SUNNINGDALE PARISH COUNCIL

**21/01053/FULL: Garden Cottage, Dry Arch Road, Sunningdale Ascot SL5 0DB
Replacement dwelling with basement, sunken garden and steps and new vehicular and pedestrian access
following demolition of existing dwelling and outbuilding (part retrospective)**

The Planning Committee considered this application at its meeting on 27 April 2021 and **Strongly Object** to this application.

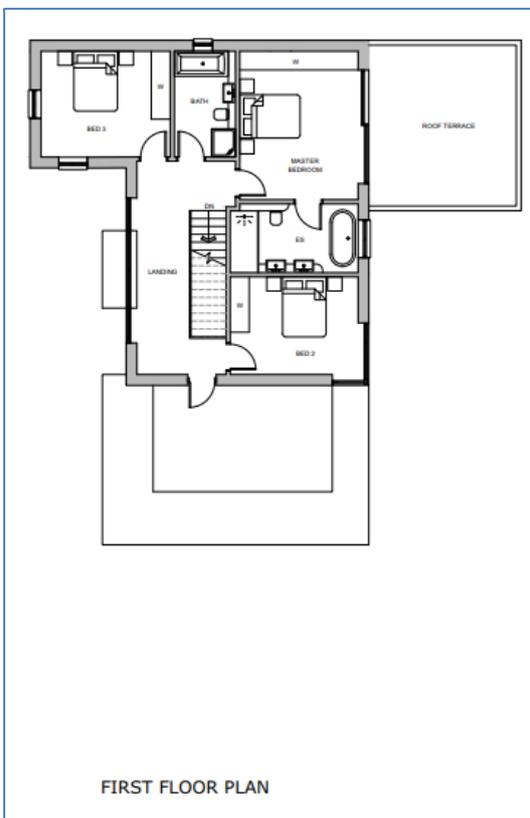
The extant scheme is 40% larger than the existing building (main dwelling and outbuilding). Therefore, ANY increase in size over the extant scheme (17/02140) would be unlikely to receive planning consent if the Inspector's rationale is followed.

21/01053

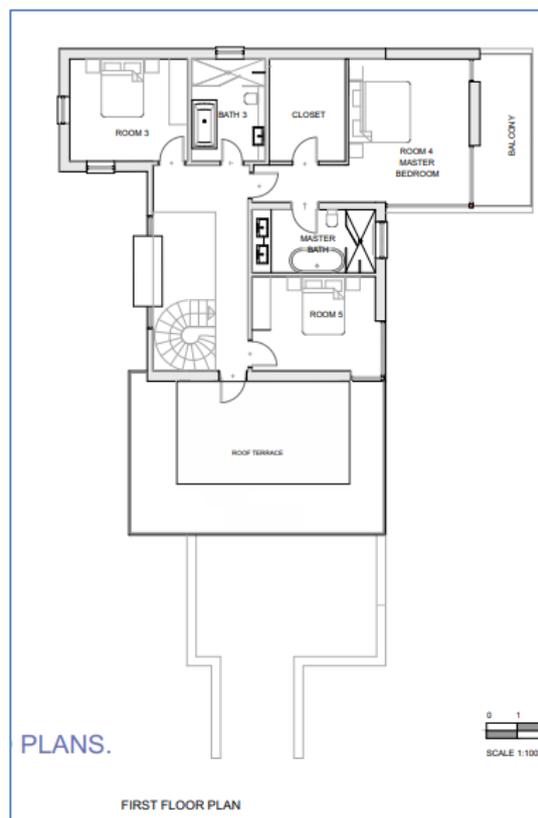
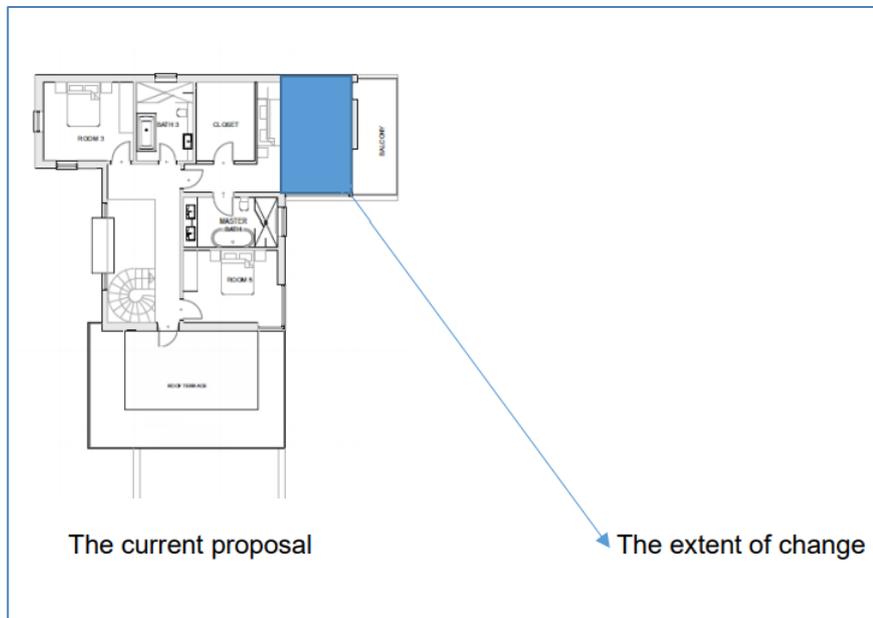
The current application 21/01053, shown below, is a larger house on the first floor along the Northern boundary than that approved in 17/02140. The differences on the first floor can be seen below. An open roof terrace on the approved scheme is now a new closet and extended bedroom 4.

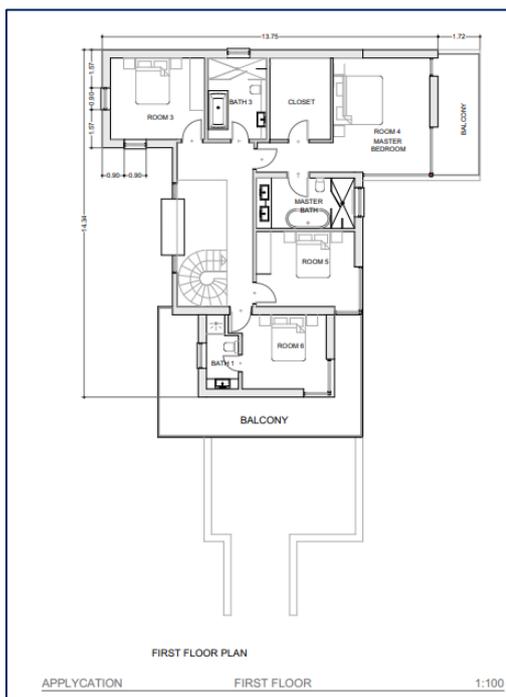
However, the public view from Dry Arch Road is very different from the public view from the footpath that runs immediately adjacent to the property and parallel with the railway line. This view is shown below of the rear of the property, photographed from the footpath.

As can be seen, the property is at an elevated height from this footpath and the proposed first floor extension would be in full public view. The applicant makes reference to this footpath in the Design and Access statement.

19/00351, First floor

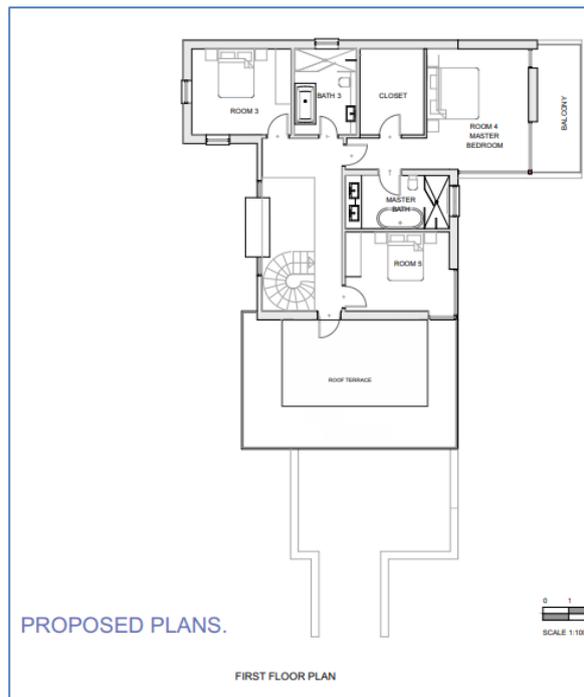
Interestingly, the first-floor plans submitted for 21/01053 along this Northern side are identical to the first-floor plans submitted for 19/00351 which, as we know, was refused.

17/02140 (shown on the left);

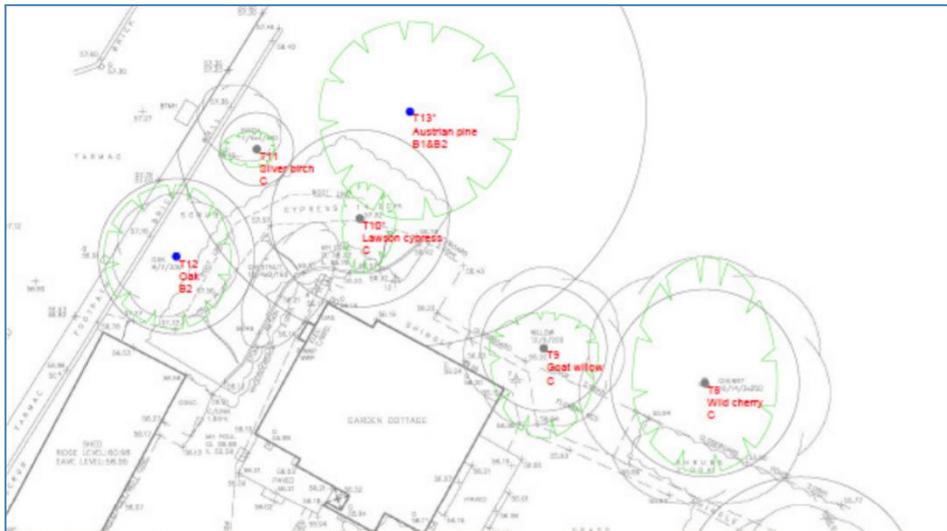
As can be seen in the submitted plans below, comparing the basement and ground floor of the approved 17/02140 with the proposed scheme with 21/01053 the building now extends further along the boundary with the adjacent property.

Significantly, the proposal is to extend the basement and the ground floor further along the Northern boundary in an Easterly direction than on the approved plan. The plan drawing shows the new basement and ground floor extensions just abutting the RPA of T9 (Goat willow). The RPA of T9 (wild cherry) does not appear to be affected. Excavating on site to create an enlarged basement is likely to also involve digging out at an angle to prevent any earth wall collapse. However, there is no arboricultural report accompanying 21/01053 which might have commented on how the construction of this enlarged basement may affect the RPA of any nearby trees. It is believed that the RPA of the Austrian pine is unaffected. The RPA of that tree (T13) is shown below.

19/00351- refused at Appeal

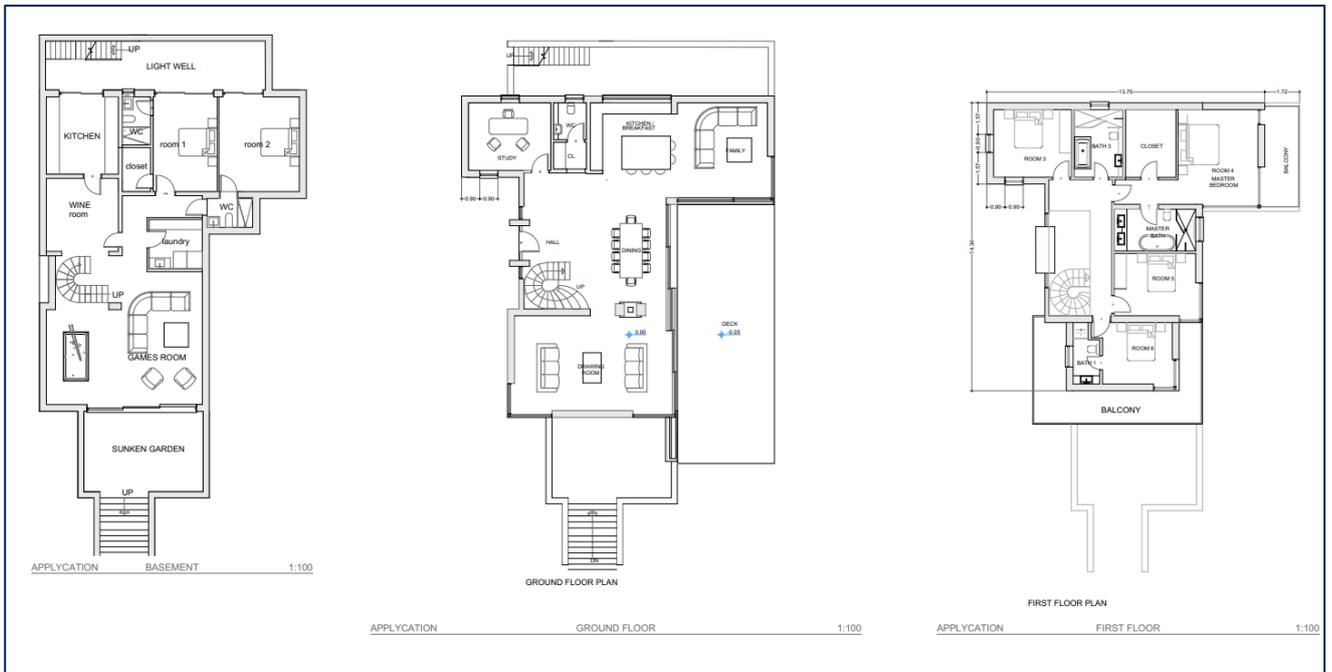
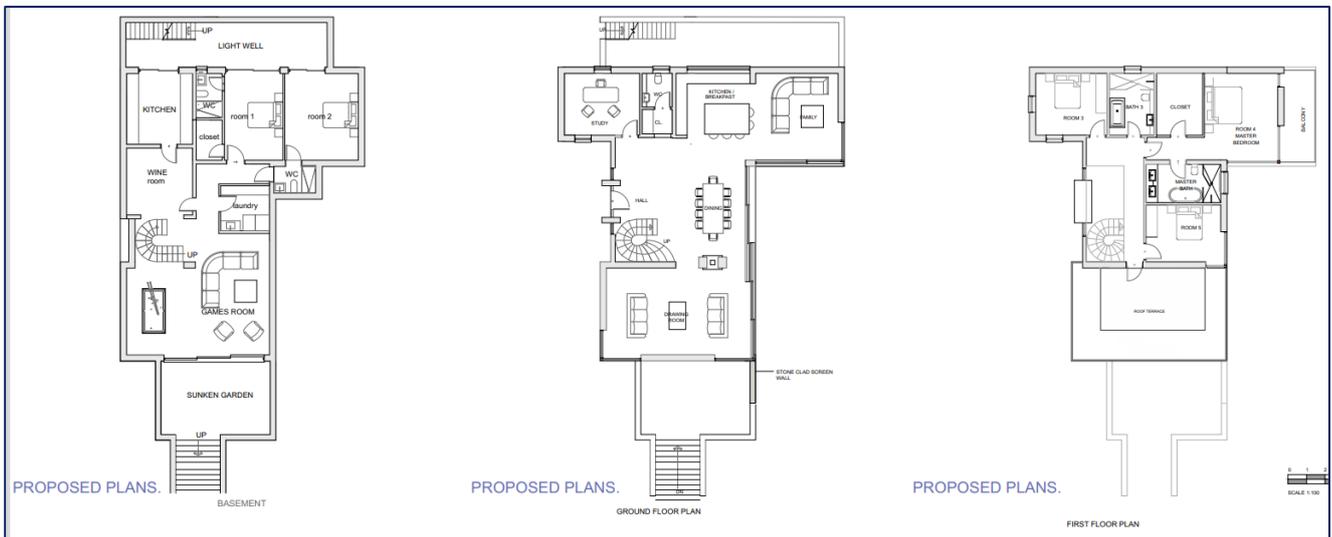
The applicant has made limited reference to the differences between the refused scheme and the current proposal. Comparing the plans (shown below) the Parish Council note the following:

- a. **Basement**
Identical to the refused scheme
- b. **Ground floor**
Removal of outside decking area on current scheme
- c. **First floor**
Removal of 1 x bedroom on Southern end of floor on current scheme
